**Re: Application SSD-9813
Gosford Alive
136-148 Donnison Street, Gosford (Lot 6 DP598833 and Lot 1 DP540292)
Applicant Lederer Group Pty Ltd**

The following comments are made by the Central Coast Council on the proposed Masterplan and Stage 1 – Demolition.

Figure 8.1: AM (PM) [Sat] peak hour site generated traffic volumes

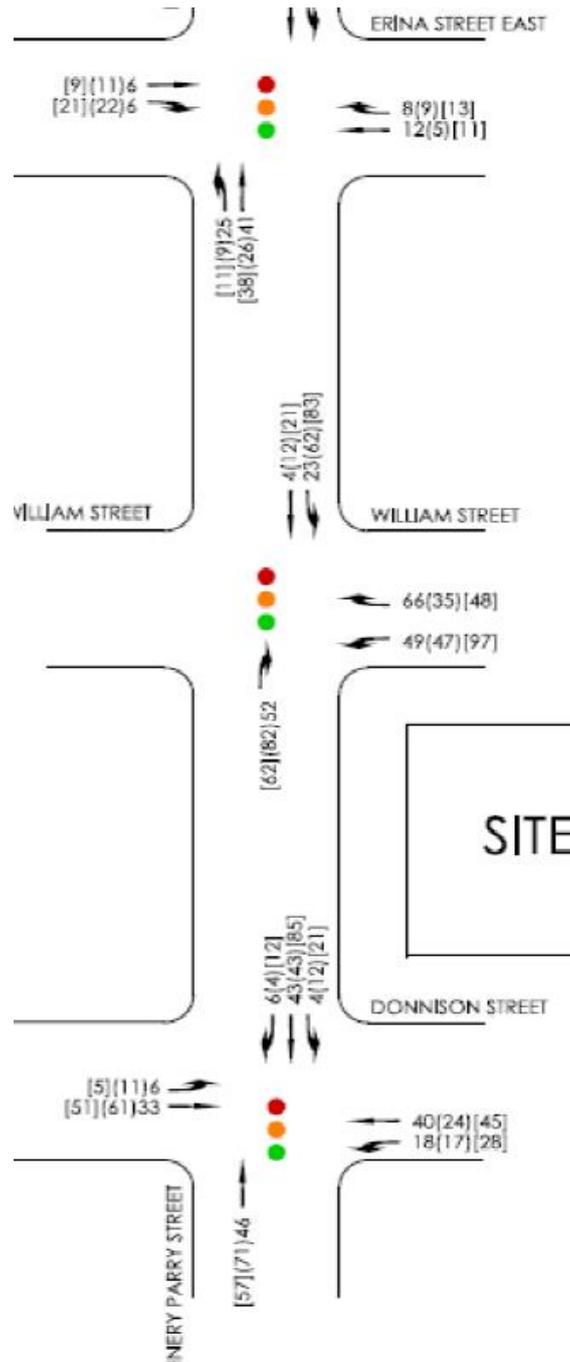
- The Donnison Street approach to Henry Parry Drive signals appears to have low existing traffic volumes for through and left into Henry Parry Drive. Due to the difficult topography there are existing right turn bans from Henry Parry Drive into Donnison St (west) and Donnison St (west) into Henry Parry Drive which are likely to be retained.

The net increase in development traffic for right turns is shown below for AM, PM and weekend peak hours is shown below. For all three peak periods assessed the Development right turns from Henry Parry Dr into William St are likely to continue to be too high for the capacity of the right turn bay in Henry Parry Drive.
